TECHNICAL NOTE RESPONDING TO COMMENTS RAISED BY WOKINGHAM BOROUGH COUNCIL ENVIRONMENTAL HEALTH IN RESPECT TO THE PROPOSAL TO REMOVE CONDITION 32 (REF 241926) AT HEADLEY ROAD EAST, WOODLEY

The purpose of this Technical Note is to respond to comments raised by Wokingham Borough Council Environmental Health in response to the proposal to remove Condition 32 of Appeal Reference: APP/X0360/W/22/3306963, dated 22nd December 2023, through Section 73 of the Town and Country Planning Act, 1990. The proposal is to remove the restriction on the permitted hours of deliveries such that deliveries can be accepted or dispatched from Units 9 and 10 throughout the night-time period (2300 hrs to 0700 hrs). The comments received as detailed in a memorandum dated 8/8/2024 and corresponding ACCON responses are detailed below:

Figure 1: CadnaA Screenshot (Facing North from a 5m Height)

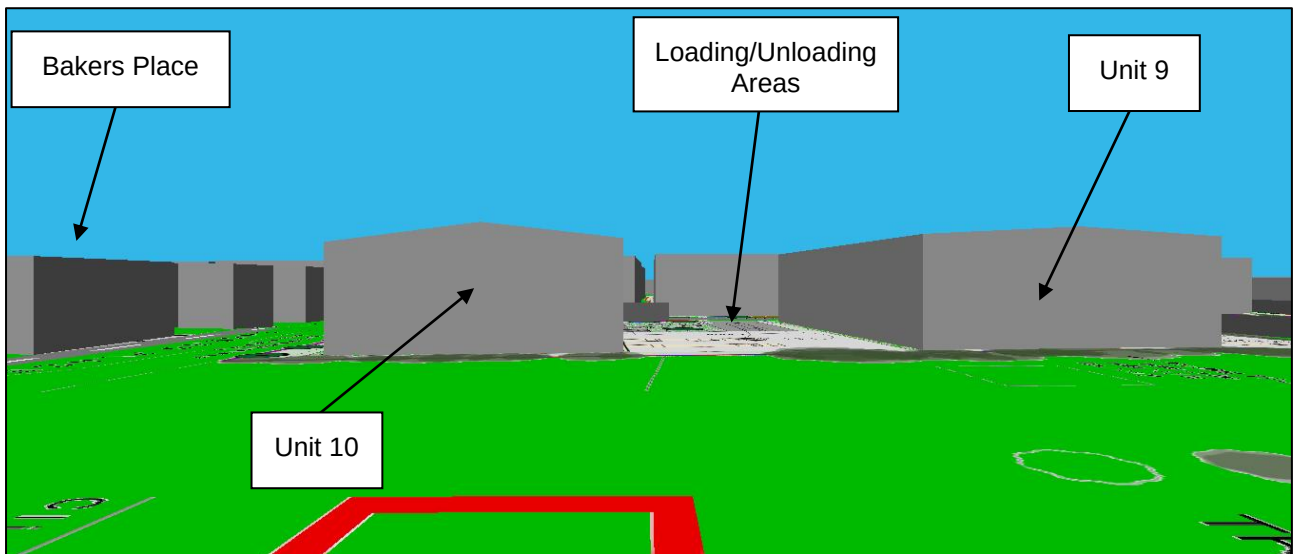
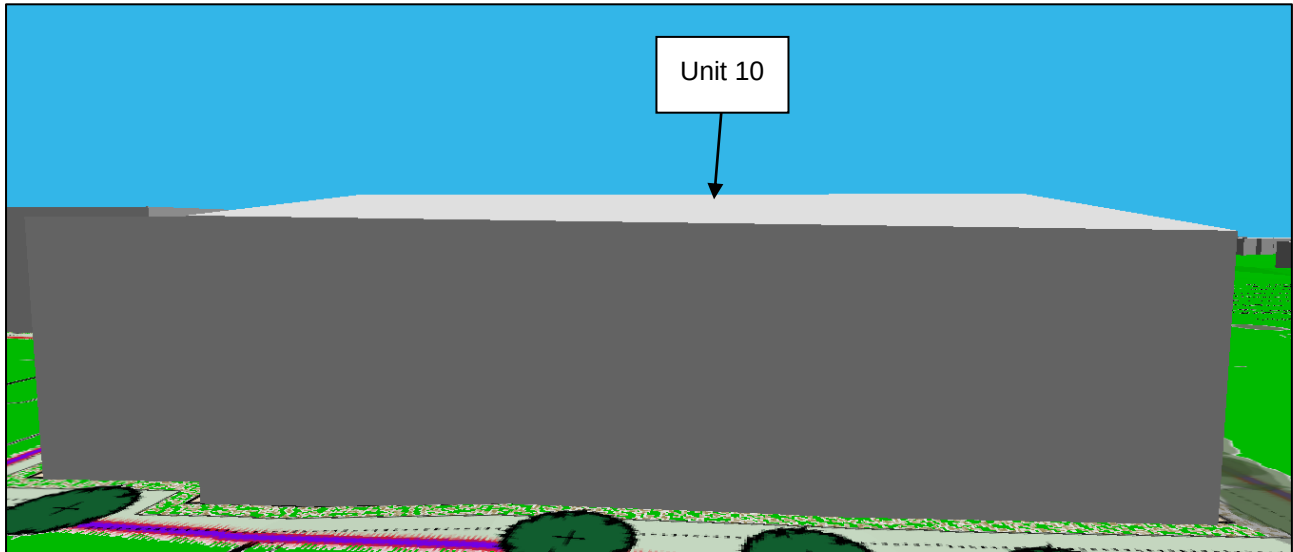
3) The NSR (nearest sensitive receptor) for noise for unit 10 is shown as Lilly May Court, there are some other residential properties also in close proximity to the expected loading area for unit 10 along Bakers Place, are these considered to be shielded from loading unloading noise by the fabric of the building? In which case can a drawing clearly defining this and showing the expected loading unloading area(s) be presented and the reasoning shown in the report.

Figures 1 and 2 illustrates screenshots from the CadnaA Noise modelling software that depict Bakers Place in relation to Units 9 and 10, and the Loading/Unloading areas.

Figures 1 and 2 illustrate that Bakers Place lacks a direct line of sight to the loading and unloading areas, which are located approximately 50 metres from the eastern façade of Bakers Place. Additionally, the proposed Unit 10 has a ridge height of 11.2 metres and will extend approximately 3.2 metres above the second floor of Bakers Place. This will effectively act as a significant noise barrier, mitigating against any noise emanating from the loading and unloading bays.
